World Forum for Harmonization of Vehicle Regulations**Working Party on Automated/Autonomous and Connected Vehicles****Eleventh session**

UN Regulation No. 90**Proposal for amendments to UN Regulation No. 90
(Replacement brake parts)****Submitted by the expert from Italy***

Annex 7a

Figure 1

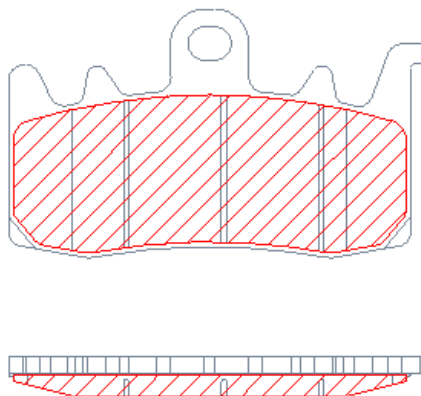
- (a) According to the individual friction material of the brake lining;
- (b) Depending on the area of the friction material area of the brake lining assembly operated by the piston/pistons of only one side of the brake caliper **or, in case of drum brakes, of only one brake shoe.**

Friction material area means all the area enclosed within the perimeter of the brake lining (see the red cross-hatched area, Figure 1, **Figure 2**), thus excluding the presence of any grooves and/or chamfers:
